**Supplement II in Response to Data Requests
1 through 104 and April 25 Workshop Queries**

Walnut Creek Energy Park

City of Industry, California
(05-AFC-02)

FIGURE 1
WALNUT ENERGY PARK
AREA OF POTENTIAL IMPACT
OF AMMONIA CONCENTRATIONS
GREATER THAN 75 PPM
CITY OF INDUSTRY, CALIFORNIA

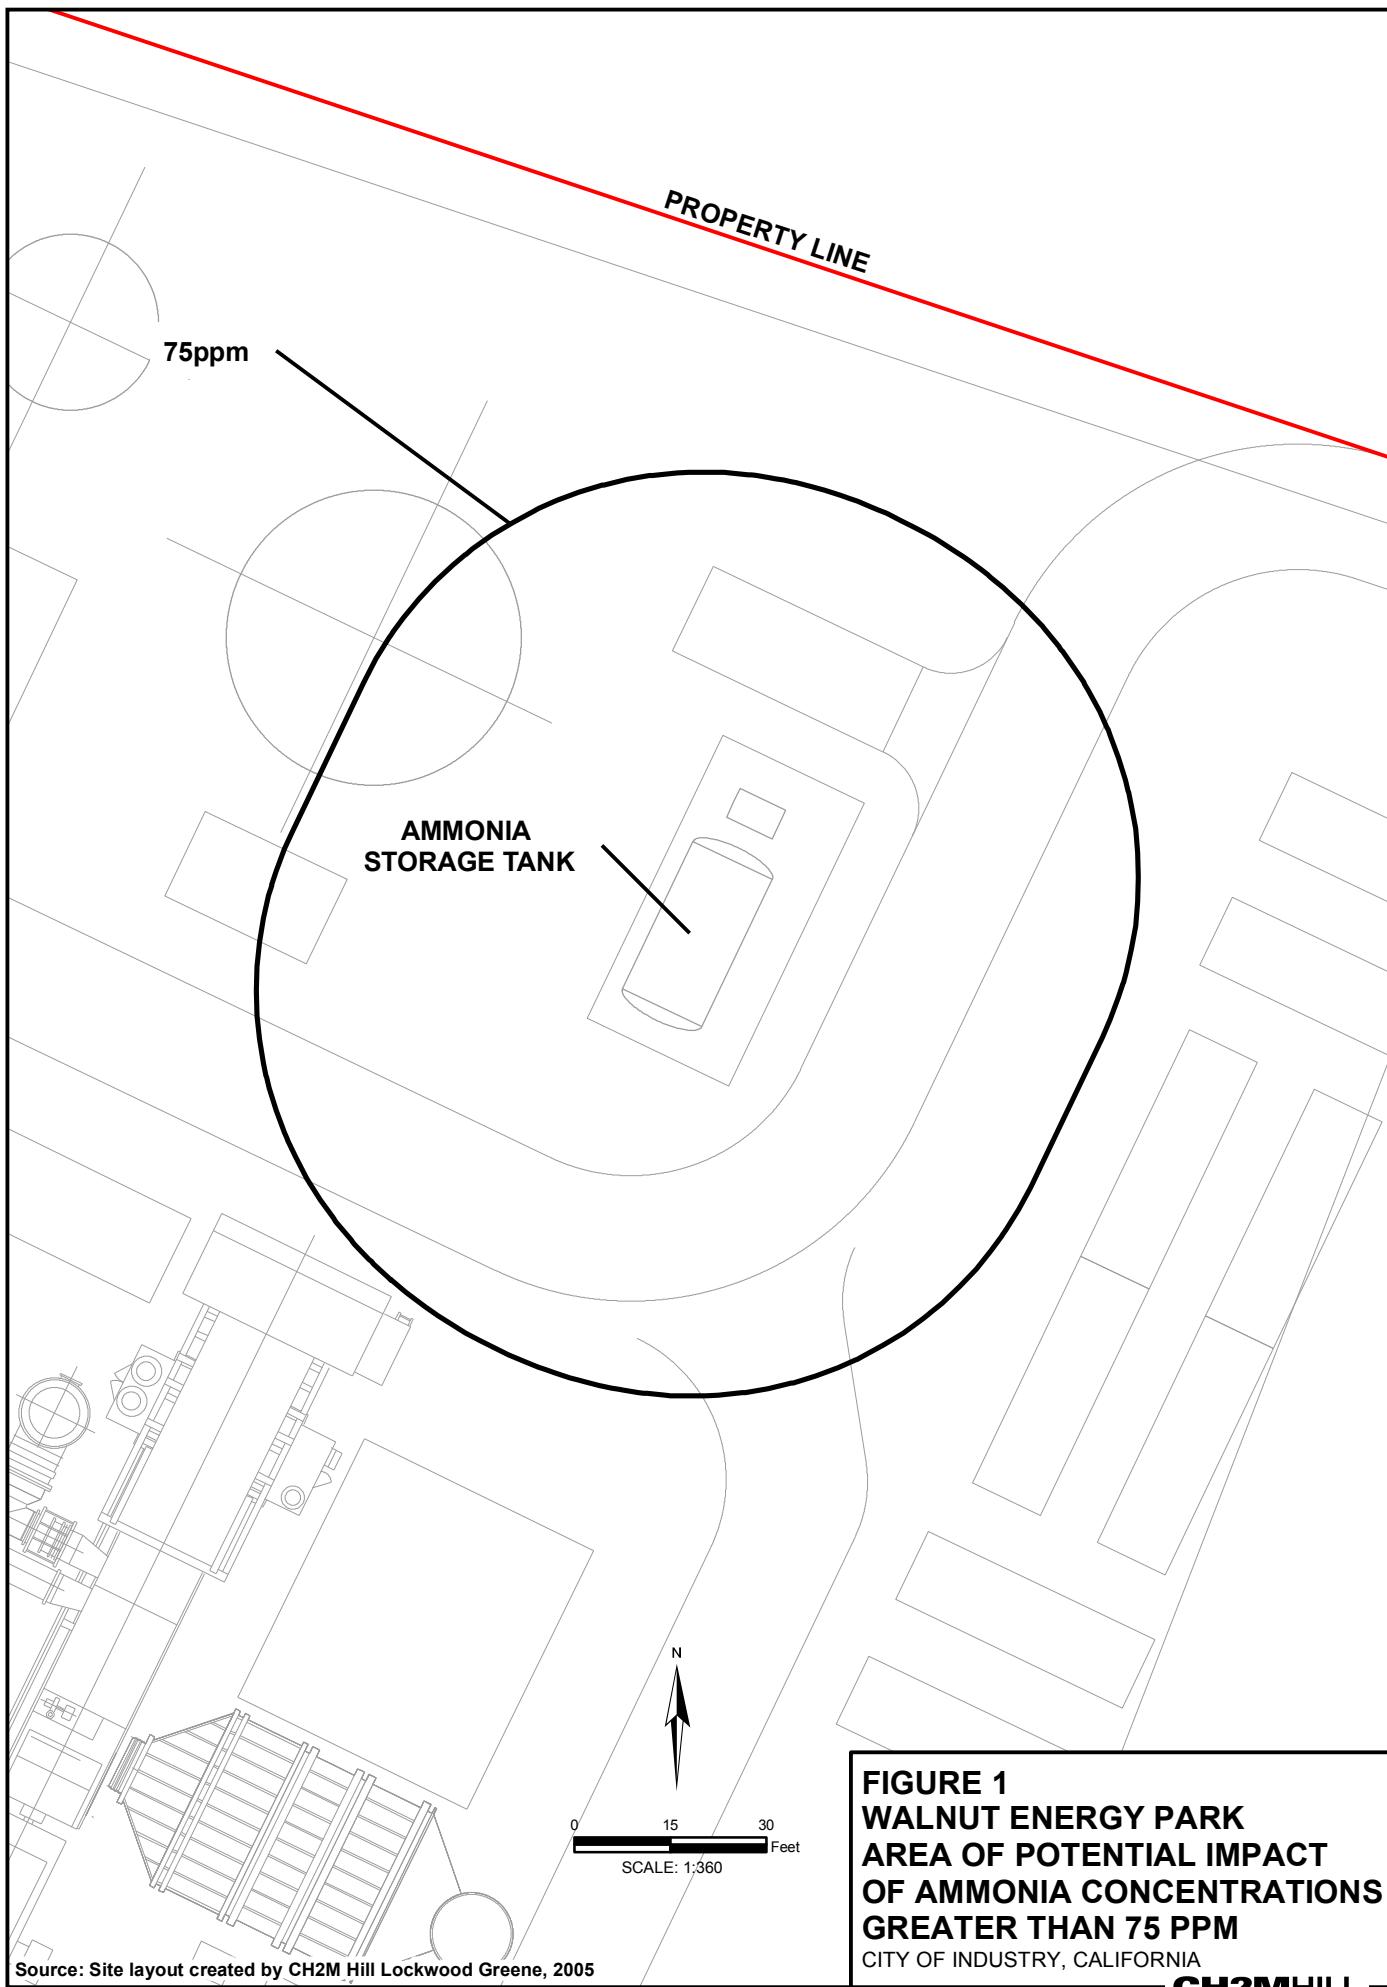
WSQ-9. *Please provide an analysis of the off-site consequences of an accidental rupture of the aqueous ammonia storage tank.*

Response: Attachment HAZ-1 is a technical memorandum reporting the results of the offsite consequences analysis.

The results of the off-site consequence analysis for the worst case release scenario of aqueous ammonia at WCEP indicate that concentrations above the most stringent benchmark criteria (CEC's significance value of 75 ppm) would not extend off the project site (see Figure 1). In the event of the failure of the storage tank and the complete discharge of the maximum potential volume of aqueous ammonia, concentrations of ammonia gas in air at, and near ground level would not exceed 75 ppm at an offsite receptor.
